*Southern California Edison Company*

Subject: Docket Nos. 50-361 and 50-362  
San Onofre Nuclear Generating Station  
Units 2 and 3

RESPONSES TO NRC QUESTIONS  
SAN ONOFRE NUCLEAR GENERATING STATION  
UNITS 2 & 3

SEPTEMBER 3, 1980

Figure 121.21-12

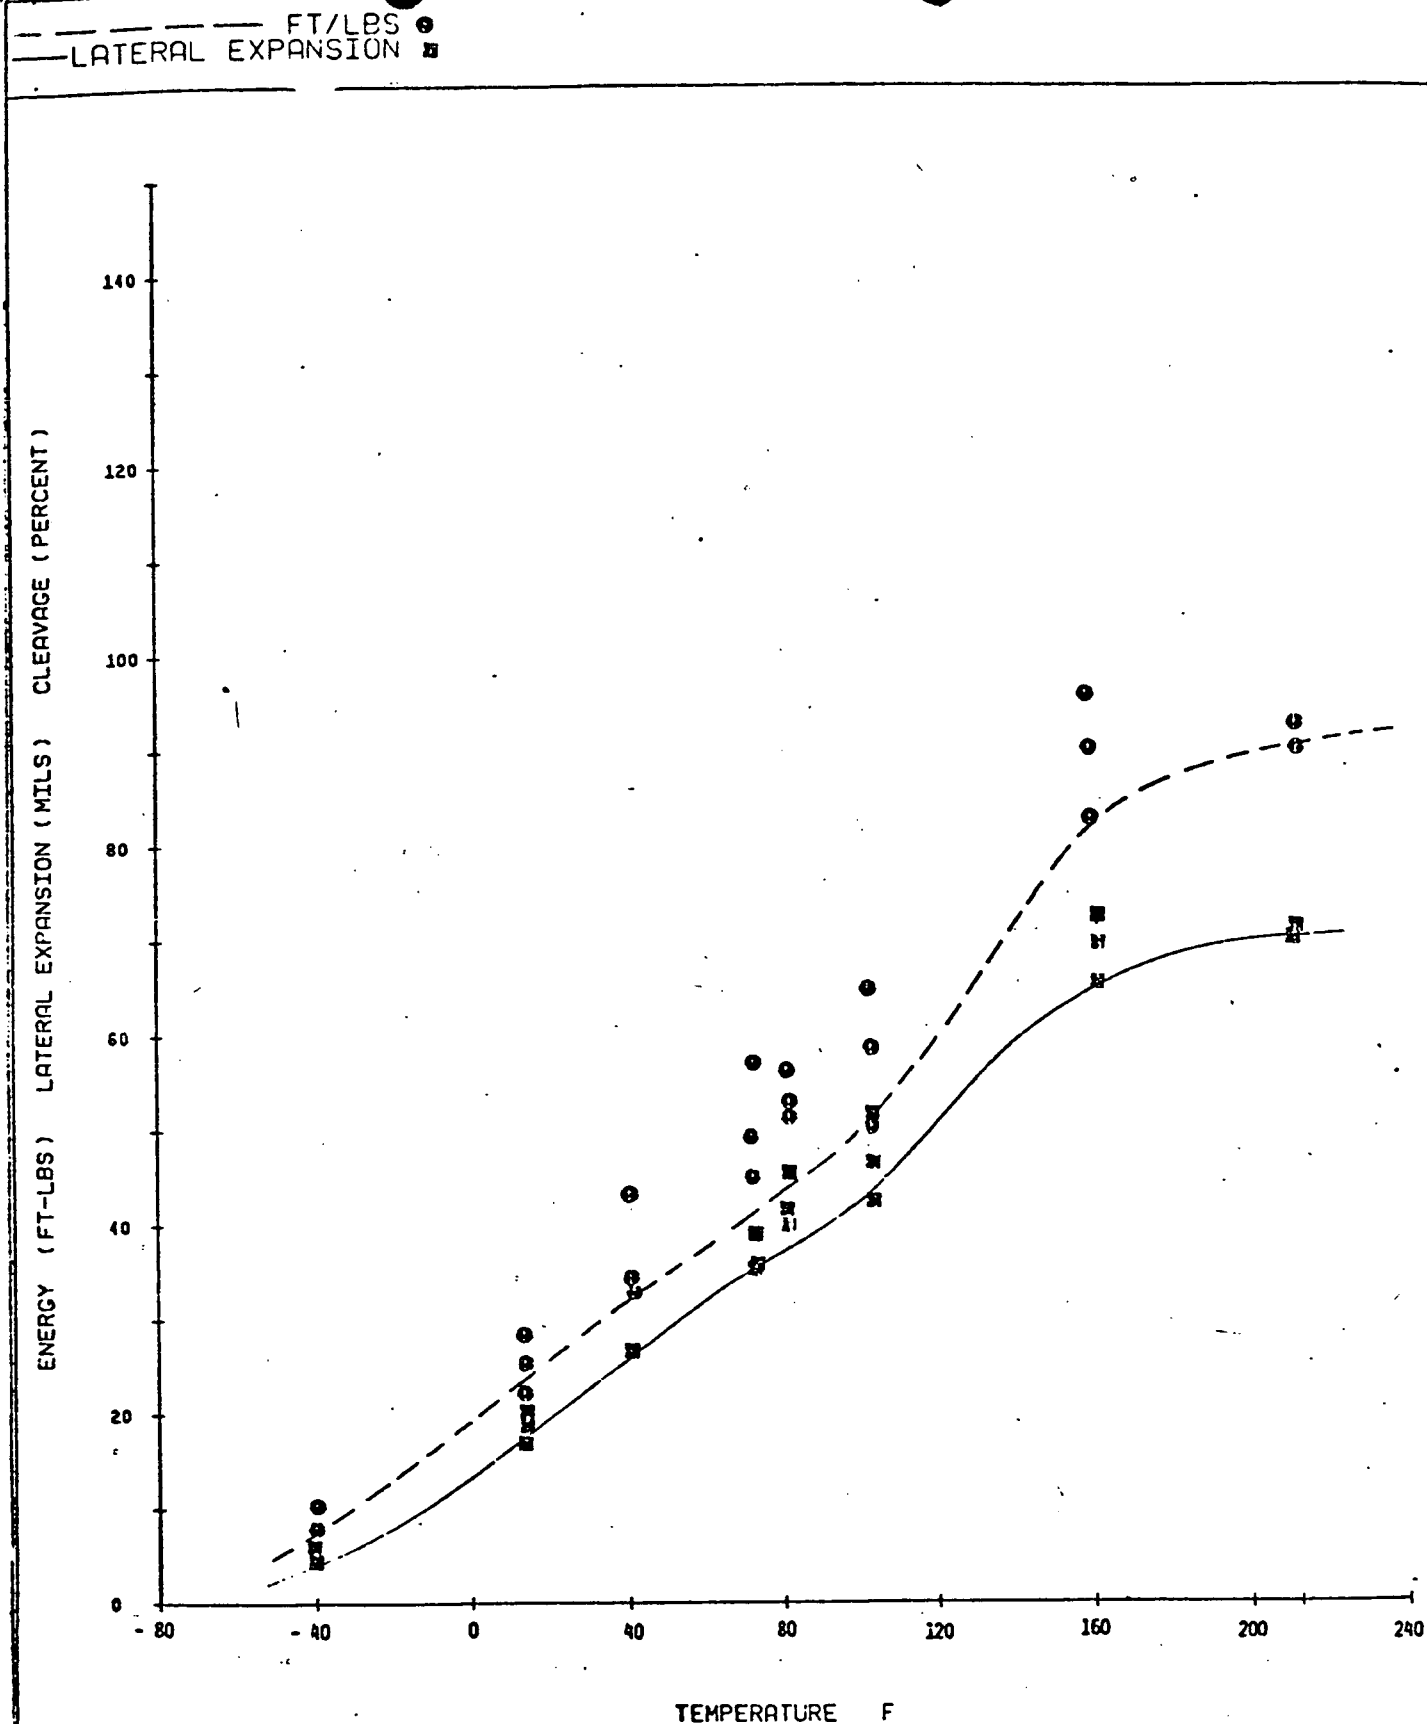
- (1) for the reactor vessel beltline materials, provide full Charpy V-notch curves, including data points, reported in impact energy and lateral expansion, both as a function of temperature;

- (1) Beltline materials Charpy test results for Units 2 and 3 are shown in Figures 121.21-1 through 121.21-12, respectively. The data points have been included. Tables 121.12-1 through 121.21-12 provide the data in tabular form corresponding to the Figures. The revised FSAR figures will be provided by 9/15/80 showing the Charpy test results.

FIG. 121.21-14 CHARPY V-NOTCH TEST RESULTS

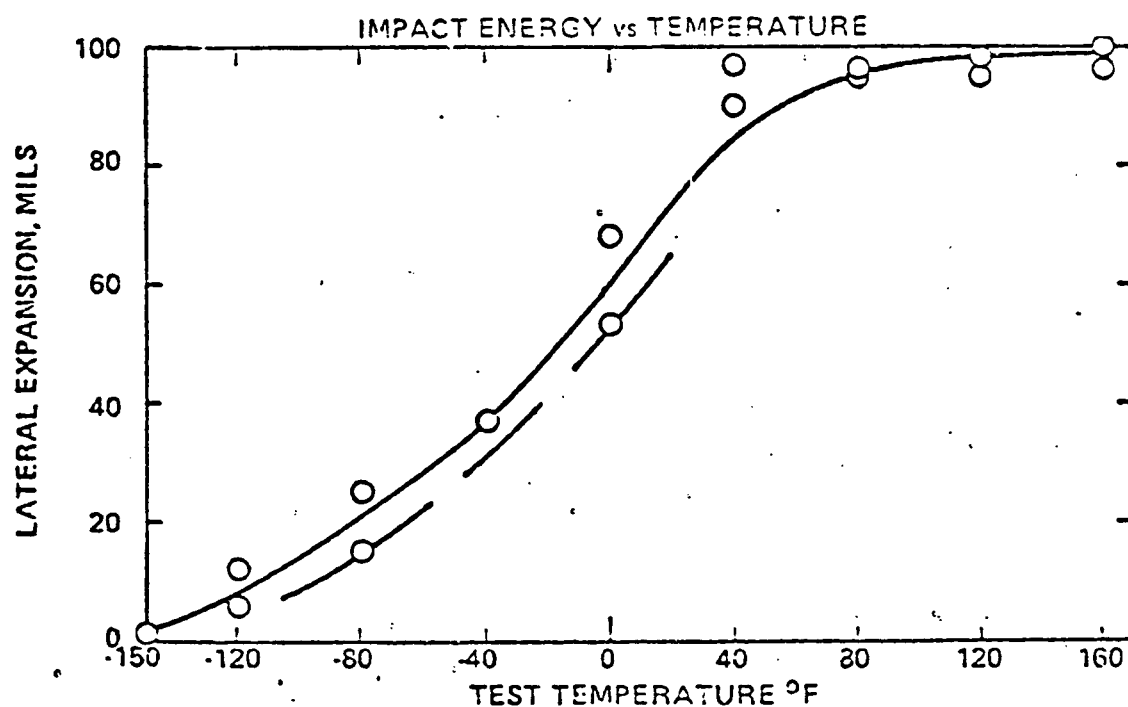
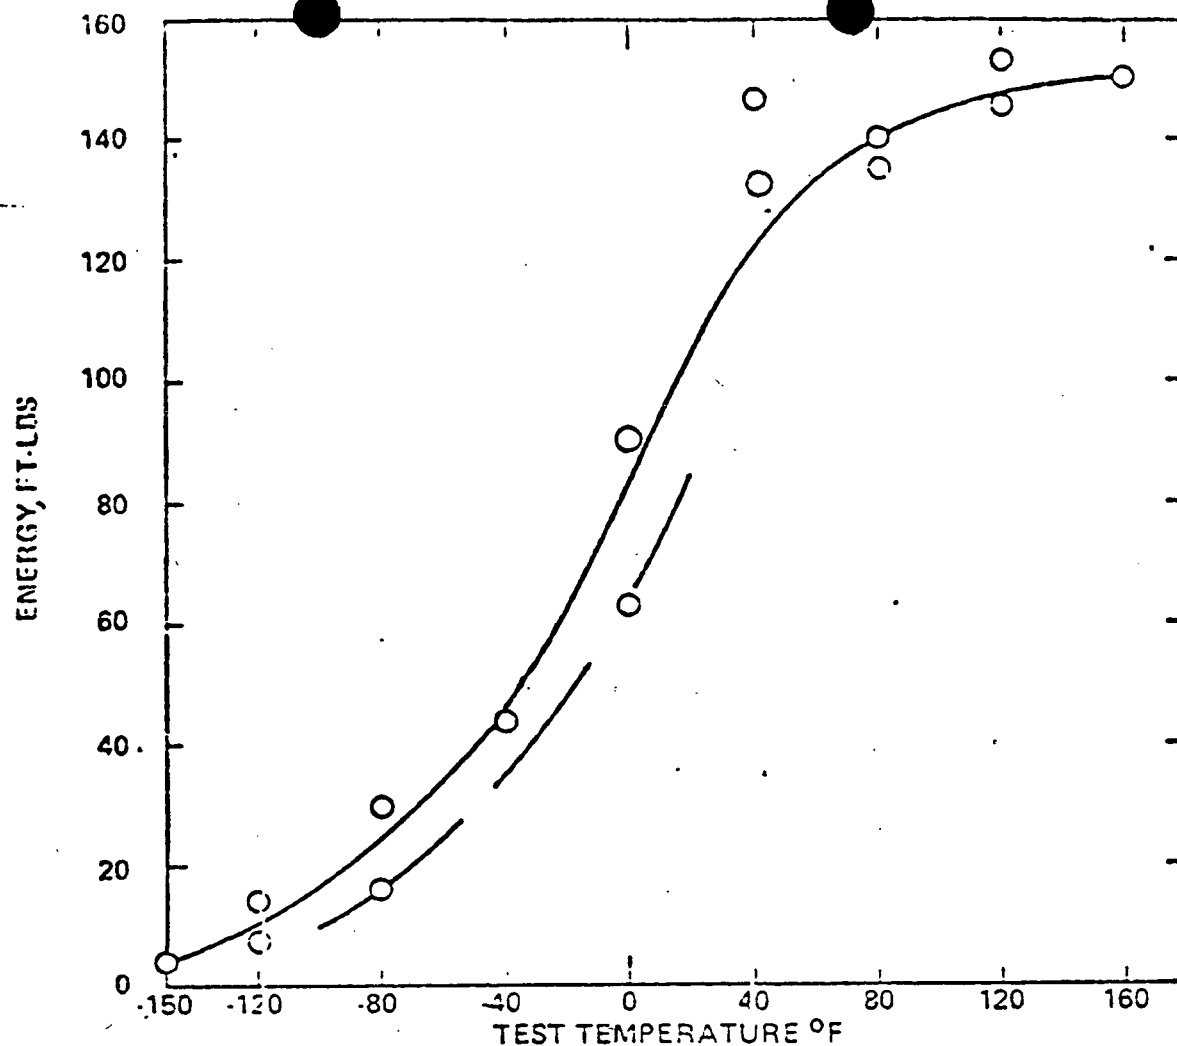
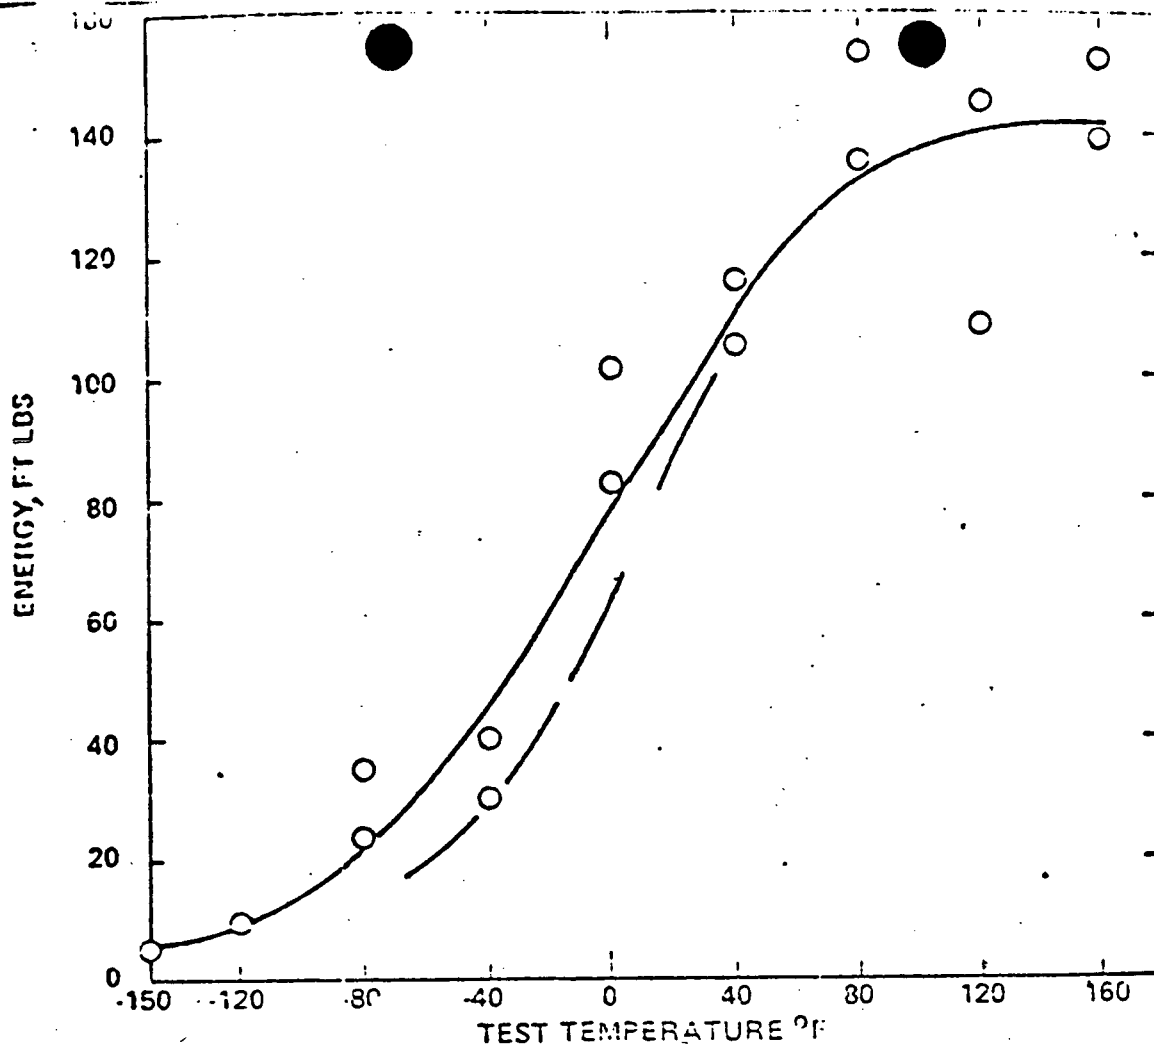
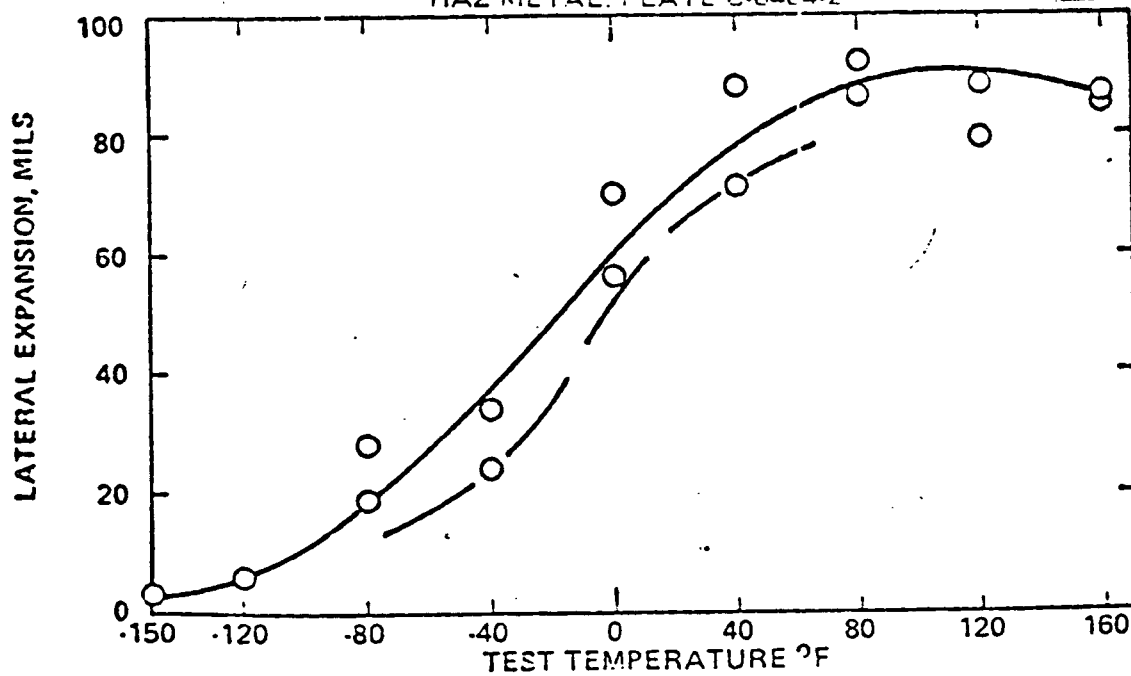
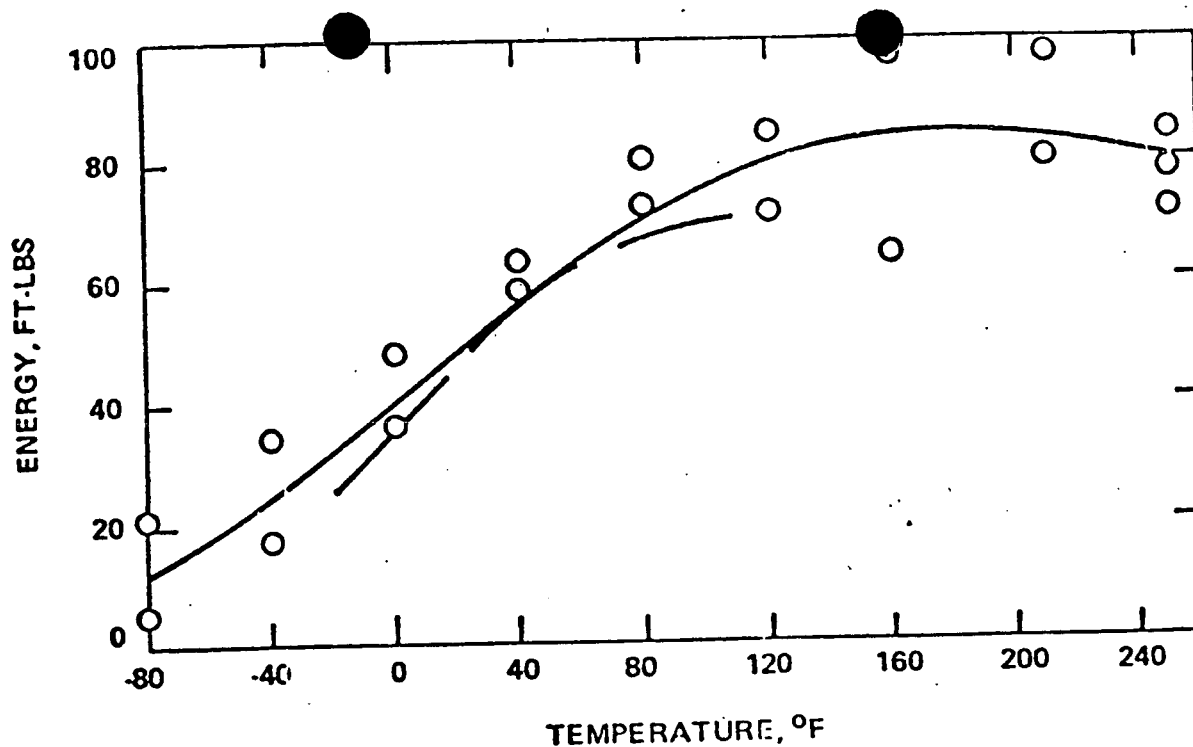
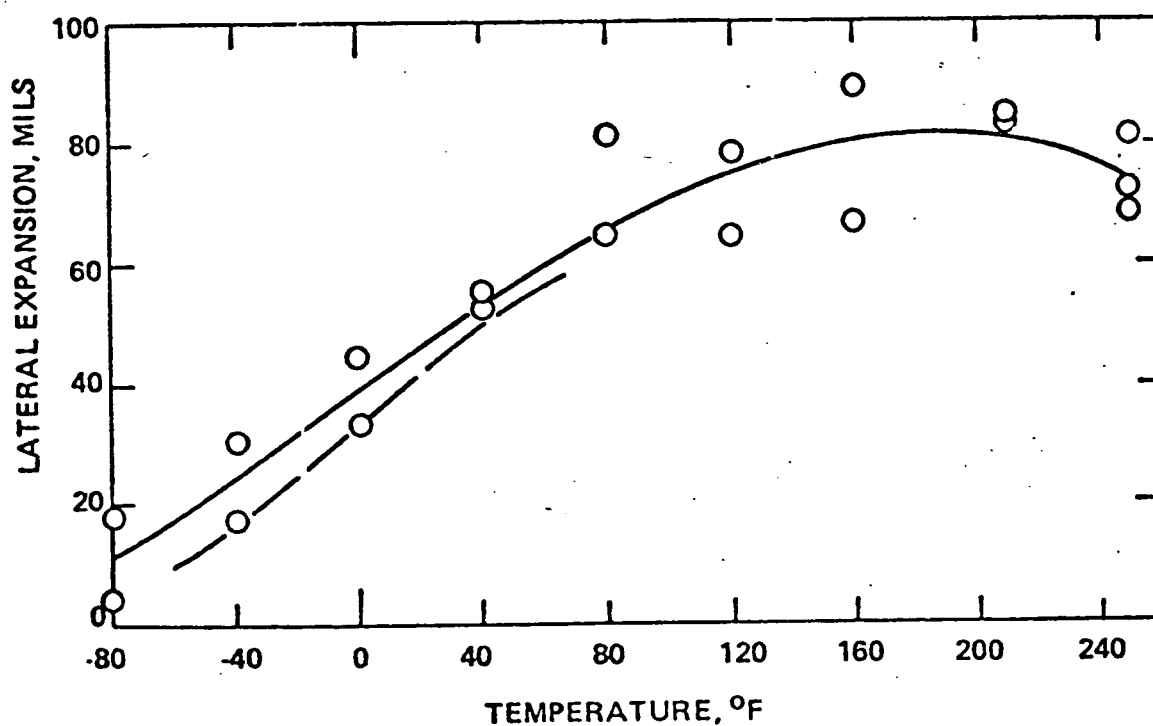
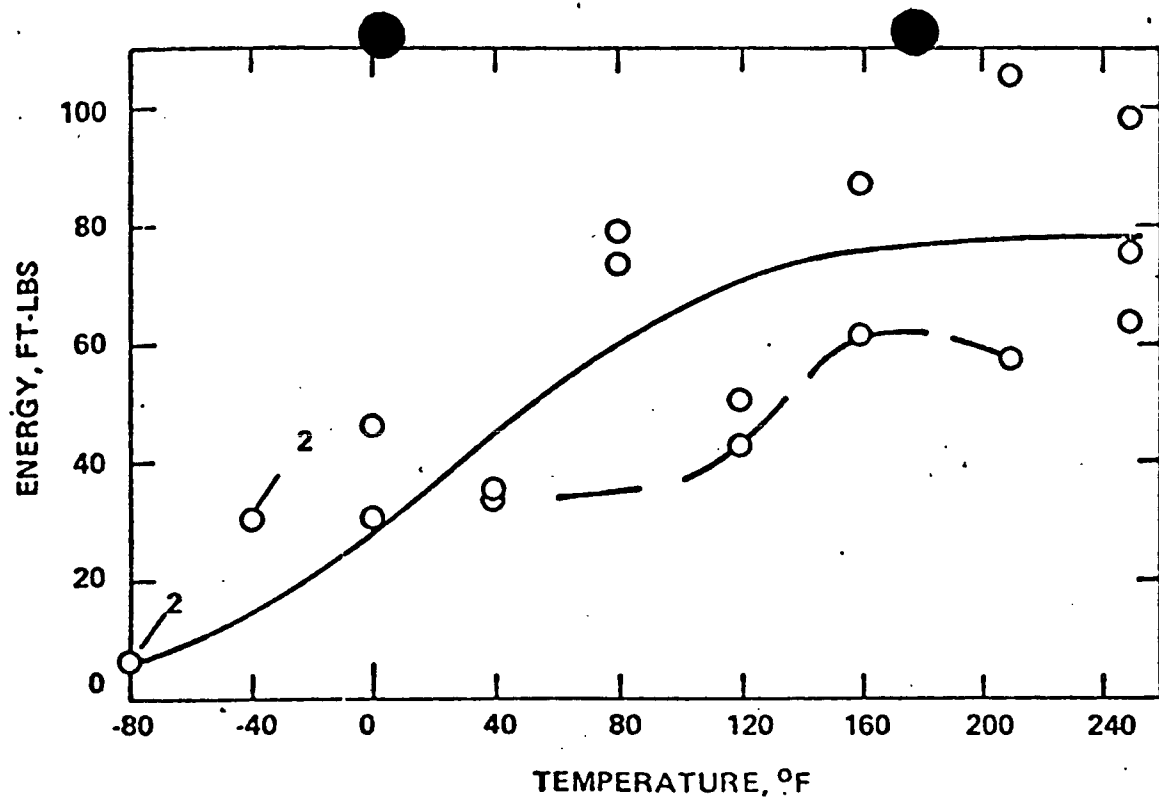
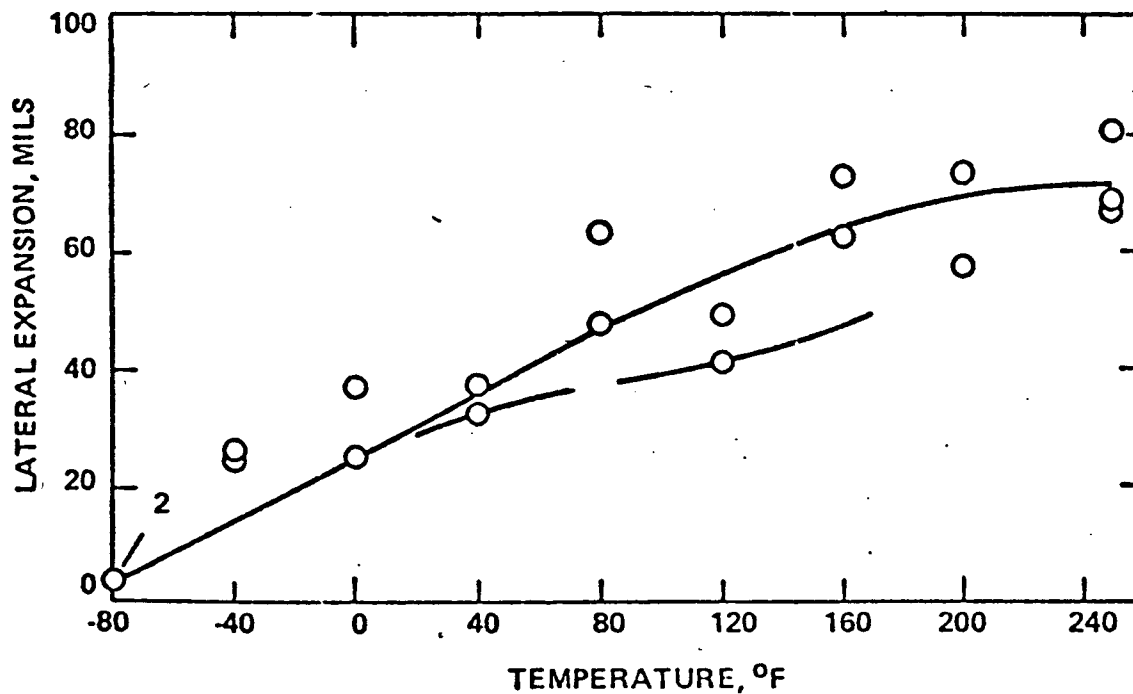
- (2) for welds and weld heat-affected-zones in the beltline region, provide fracture toughness data from either available data or additional tests. Include transition temperature data, upper shelf energy data, and the significant variables that affect fracture toughness properties, e.g., weld wire, flux, base metal combinations, and heat treatment. Correlate this information with data already presented in Tables 121.11-1 through 121.11-27, and provide analyses of the additional data to demonstrate compliance with all the fracture toughness requirements of Appendix G;

Attached Figures 121.21-13 and 14, and 121.21-15 and 16 provide additional Charpy V-notch test results for the weld and HAZ materials of San Onofre Units 2 and 3, respectively.
